Access Compliance Report

Public Rights-of-Way

(Curb Ramps)

Intersection ID: 31596	Main Street: TUMBLEWEED_CT	Cross Street: WINDY_VALLEY_DR	Location: S
ADA ID: A8321F78061B	Ramp Type: BlendTrans2	Initial Pass/Fail: Pass	Overall Compliance: No
		Severity Score: 2.75

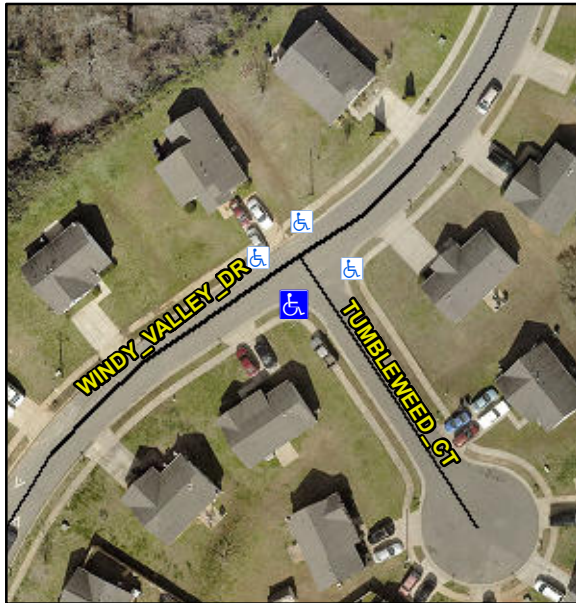
Not Found, R304.5.3, R305.1.4, R305.2

Compliance	Description	Data	Compliance	Description	Data
N/A	Ramp Length (in)	52.5	Yes	BlendTrans Slope (%)	3.9
Yes	Ramp Width (in)	54.0	No	BlendTrans XSlope (%)	4.0
N/A	Flare Type LT	Sloped	N/A	Flare Type RT	Sloped
N/A	Flare Slope LT (%)	8.5	N/A	Flare Slope RT (%)	2.6
N/A	Flare Traversable LT?	No	N/A	Flare Traversable RT?	No
N/A	Landing Length (in)	N/A	Yes	DWS Provided?	Yes
N/A	Landing Width (in)	N/A	Yes	DWS Contrast?	Yes
N/A	Landing Slope (%)	N/A	Yes	DWS Length (in)	24.0
N/A	Landing X Slope (%)	N/A	No	DWS Full Width?	No
N/A	Landing Curb? (Y/N)	No	No	DWS Offset (in)	4.0
N/A	Shared Landing?	No			
Yes	Gutter Ponding?	No	Yes	Gutter Slope (%)	0.8
Yes	Gutter Lip Ht (in)	0.0	No	Gutter X Slope (%)	2.6
N/A	Painted X Walk1?	No	N/A	Painted X Walk2?	No
	X Walk 1 Direction	To NW		X Walk 2 Direction	To NE
	X Walk 1 Width (in)	N/A		X Walk 2 Width (in)	N/A
	X Walk 1 Slope (%)	6.0		X Walk 2 Slope (%)	4.4
	X Walk 1 X Slope (%)	2.9		X Walk 2 X Slope (%)	5.0

N/A	Ramp inside XWalk1?	N/A	N/A	Ramp inside XWalk2?	N/A
	Road Slope (%)	4.2		Clear Space?	Yes
	Road X Slope (%)	3.1	N/A	Clear Space to XWalk (in)	N/A
Yes	Any Obstructions?	No	Yes	Storm Grate/Utility Hazard?	No
	Obstruction Type			Storm Grate/Utility Type	
		N/A			N/A
			Yes	Surface Condition? (G/P)	Good
			No	Curb Slope (%)	5.1

Remove & Replace Curb Ramp With Two New Directional Ramps or Equivalent. Remove & Replace Gutter.
